FDI	ENGINEERING CHANGE ORDER		ECO NO: 10-068
			Page 1 of 4
TITLE	DWG NO.	CURRENT REV	NEW REV
uEZ GUI 7	uEZ GUI 7.0 Seiko	1.2	2

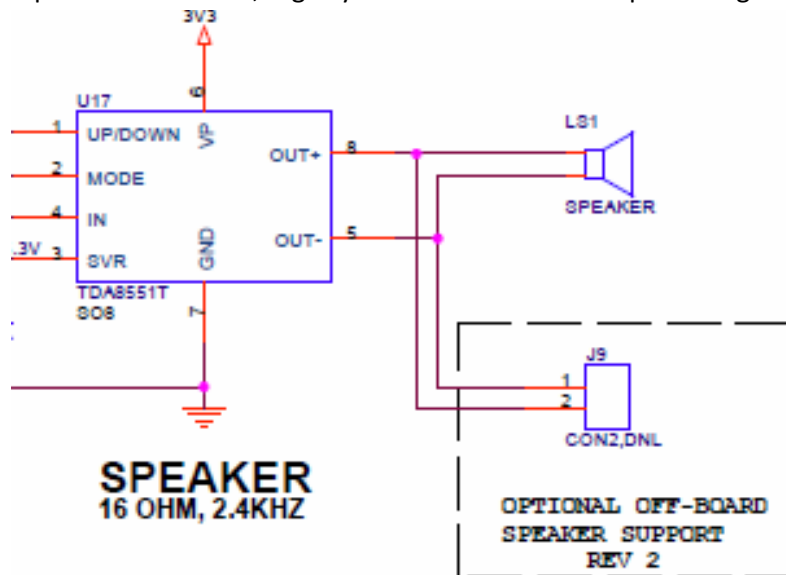
- Implement schematic changes from previous ECOs; 10-064 & 10-065
- Add optional 2pin SMT header J9, Digikey PN: H2219-ND to the speaker signals U17 pin 8 & 5

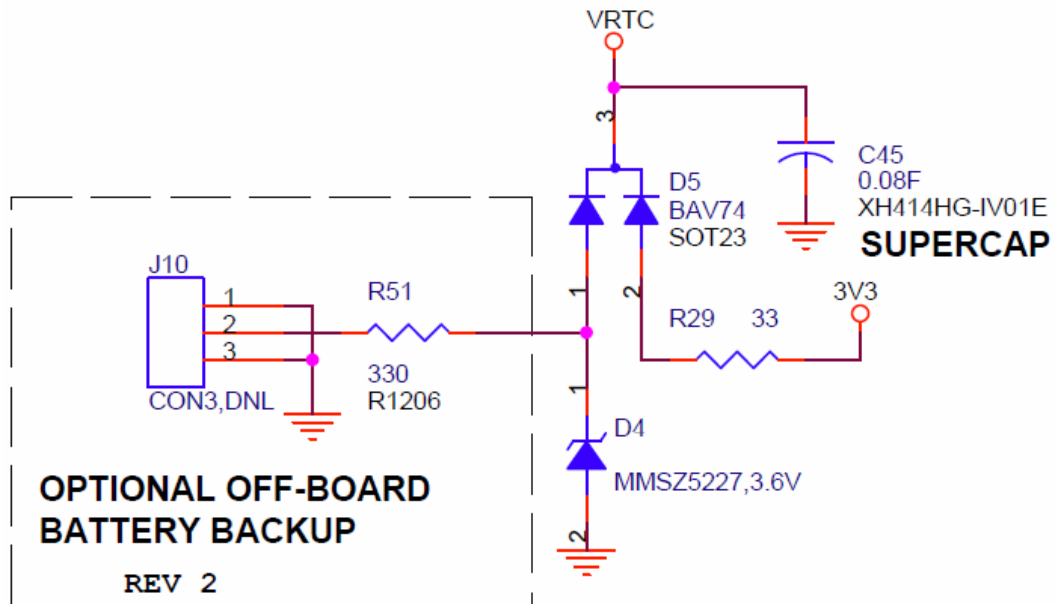
- Add optional 3-pin SMT header J10, Digikey PN: H2220-ND
- Add 330ohm 1/4W series resistor, Digikey PN: P330FTR-ND
- Add 3.6V Zener Diode D4, Digikey PN: MMSZ5227BS-FDICT-ND
- Change diode D5 from BAS416 to BAV74, Digikey PN: 568-1623-2-ND
- Connect battery backup circuit as shown below;

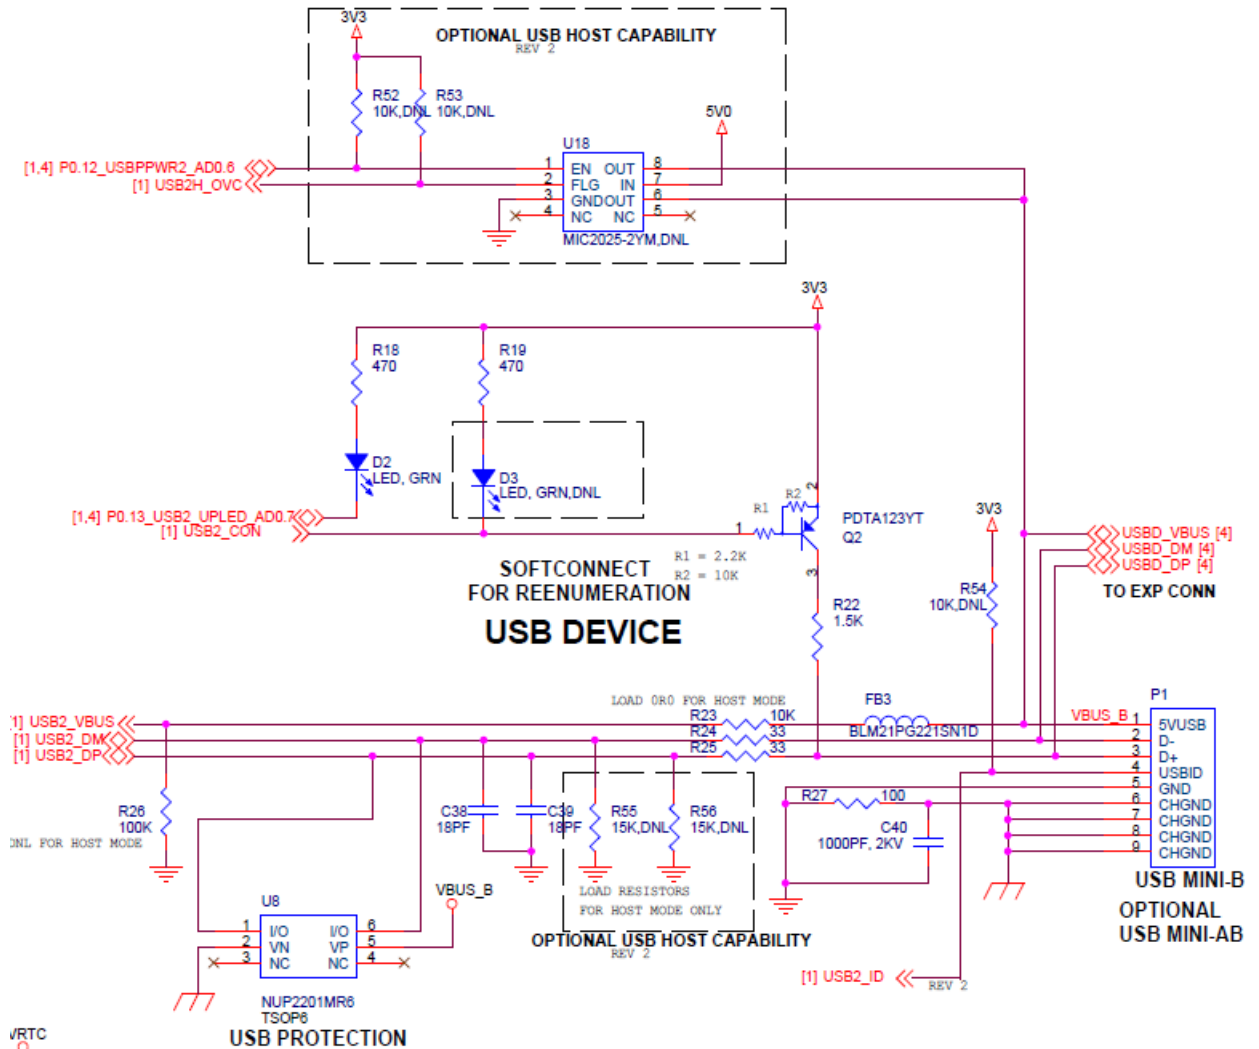
8. Add (DNL parts) MIC2025 (U18), 10K (R52 & R53), and 15K (R55,R56) circuit as shown below;

9. Connect U18 pin 6 & 8 to pin 1 of P1
10. Connect U18 pin 1 to U1 pin 41 (P0.12_USBPPWR2_AD0.6)
11. Connect U18 pin 2 to U1 pin 50 (USB2H_OVC)
12. Add load option for P1 to be USB Mini-AB, PN DX3R005HN2E700 (JAE) – this part is not normally loaded, but is optional for USB Host support configuration
